UNITED STATES NUCLEAR REGULATORY COMMISSION'S
ADVISORY COMMITTEE ON REACTOR SAFEGUARDS

MATERIALS, METALLURGY AND REACTOR FUELS SUBCOMMITTEE

MAY 6, 2020

Uranium Oxycarbide (UCO) Tristructural Isotropic (TRISO) Coated Particle Fuel Performance

SiC Microstructure Comparison

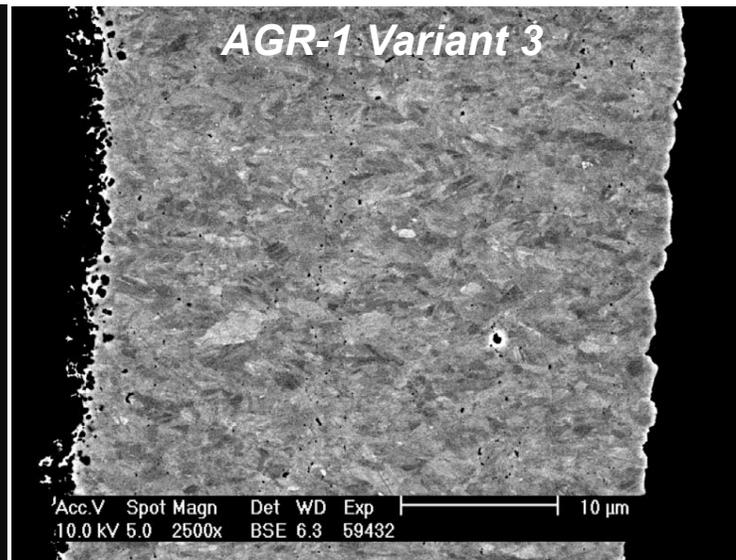
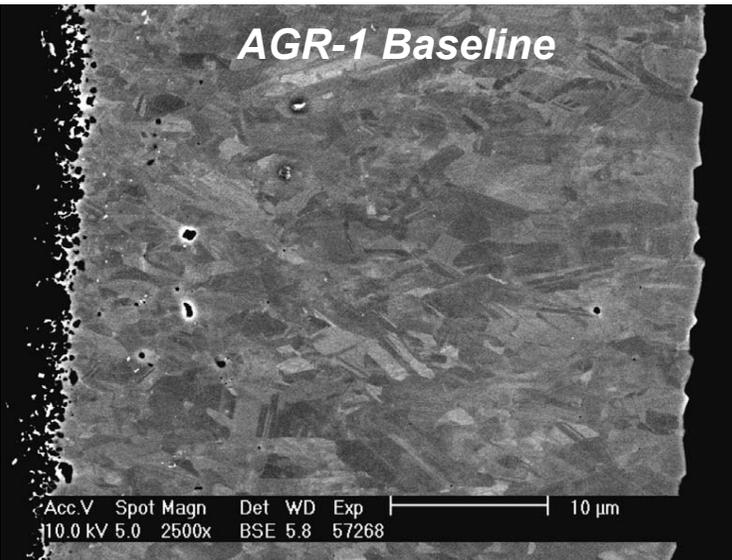
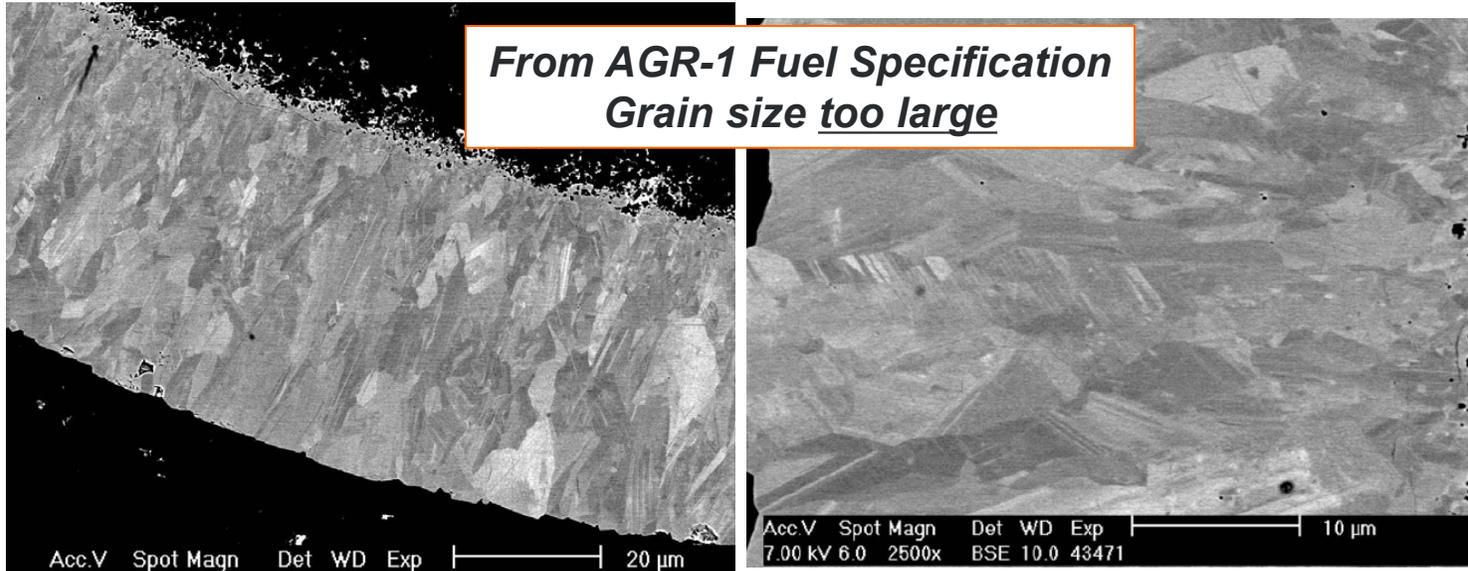
Those are known to be poor performers based on the historic database. And so this spec, the intent was to get folks, or to get the program in the right range of silicon carbide microstructure without overly specifying that for fuel fabricators. And that visual standard is shown in these two micrographs. It's been added to the report for reference. Okay. Next.

From AGR-1 Fuel Specification
Grain size too large
